# **RENESAS TECHNICAL UPDATE**

Product Category	MPU/MCU		Document No.	TN-RX*-A013A/E	Rev.	1.00	
Title	I <sup>2</sup> C bus interface (RIIC) Precautions for stop condition issuance timing when receiving master		Information Category	Technical Notification			
Applicable Product	RX610 group	Lot No.		RX610 group			
	RX62N, RX621 group		Reference Document	RX62N, RX621 group			
	RX62T group			RX62T group			
	RX630 group	All lots		RX630 group			
	RX63N, RX631 group			RX63N, RX631 group			
				User's Manual, Hardware section

Figure xx.10 Example of Master Reception Flowchart (7-Bit Address Format)

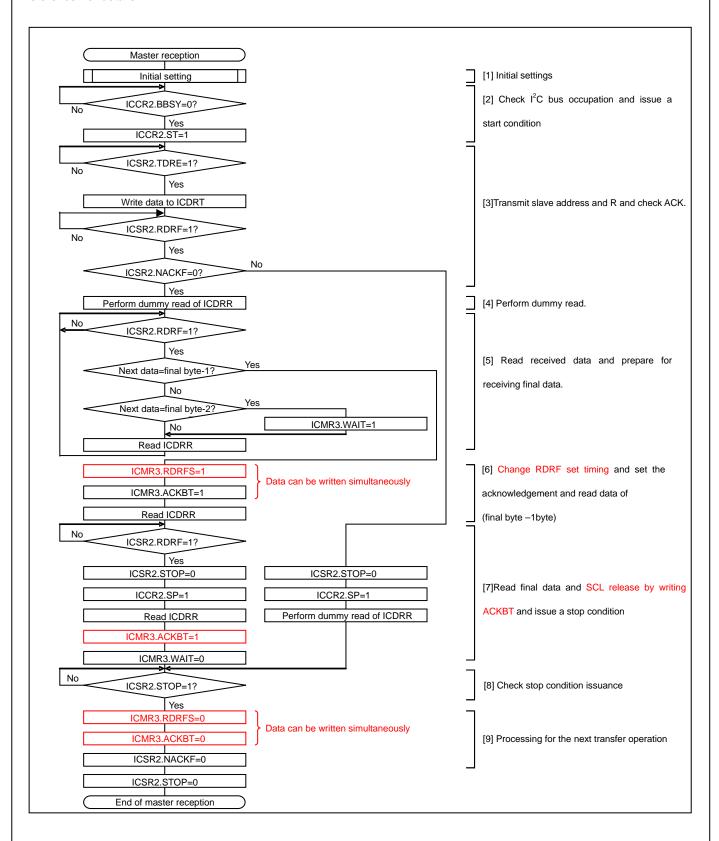
With I<sup>2</sup>C bus interface (RIIC), one clock cycle may be inserted between the ninth clock cycle of master reception and stop condition issuance.

One clock cycle is inserted between the ninth clock cycle of master reception and stop condition issuance.

One clock cycle is prevented from inserting before issuing stop condition by writing to the ICMR3.RDRFS bit and the ICMR3.ACKBT bit again when receiving master. Add the procedures marked in red indicated below to the flowchart in the user's manual.
